Subject: Final Approval of Intake Entry Portal Breakout, PacifiCorp, Deer Creek Mine, C/015/0018, Task ID #2364, Outgoing File

RE: PacifiCorp - "Deer Creek" Mine - Application for a Permit Revision, Amendment to Deer Creek Mine Permit Volume 11

Re: Minor Modification of Resource Recovery and Protection Plan (R2P2), Rilda Canyon
Ventilation Breakout, Hiawatha Seam, Deer Creek Mine.

RILDA CANYON FAN PORTAL DEVELOPMENT PLAN

**ENERGY WEST
MINING COMPANY**
HARRISON, UTAH 84033
**DEER CREEK MINE
RILDA CANYON INTAKE PORTAL
BREAKOUT - PLAN VIEW**

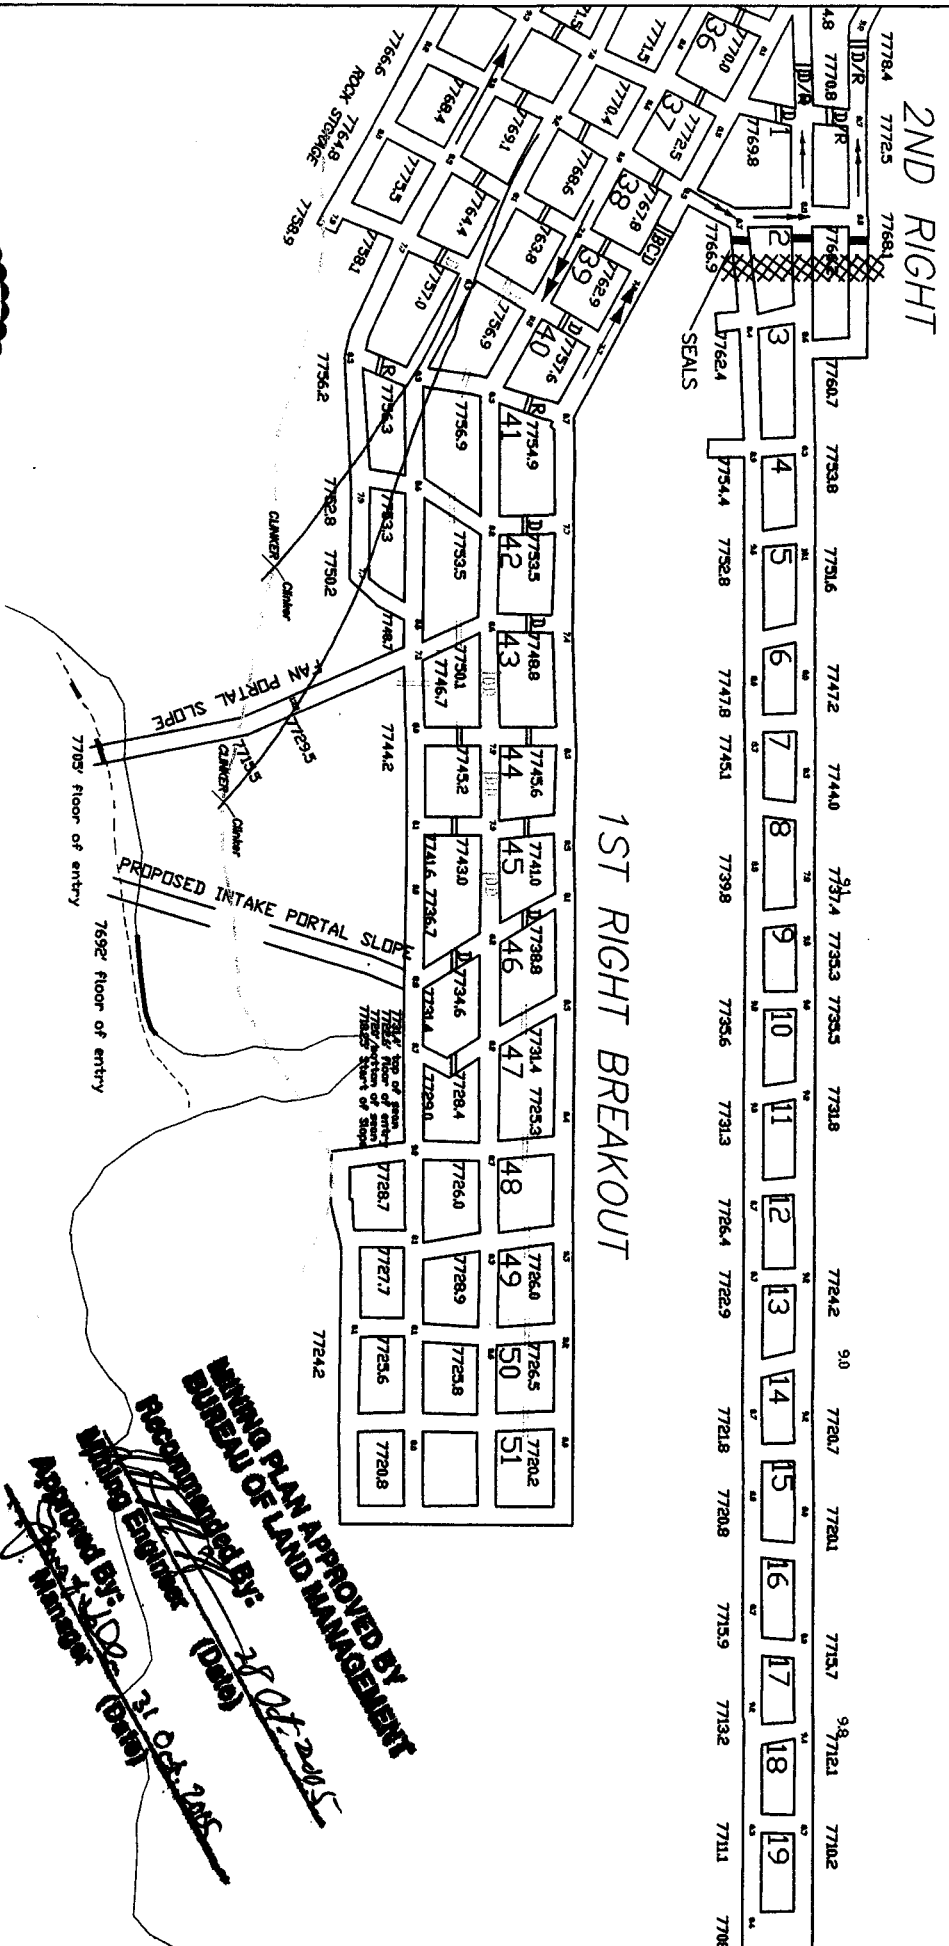
The modification of the R2P2 complies with the Mineral Leasing Act of 1920, as amended, the regulations at 3480, and the lease terms and conditions and will achieve maximum economic recovery of the federal coal. The modification to the R2P2, as depicted on Map CM-10899-DR revised 3-9-04, is approved as submitted. A copy of the approved mine map is enclosed. If you have any questions, please contact Steve Rigby at the Price Field Office (435) 636-3604 or Jeff McKenzie of my staff at (801) 539-4038.
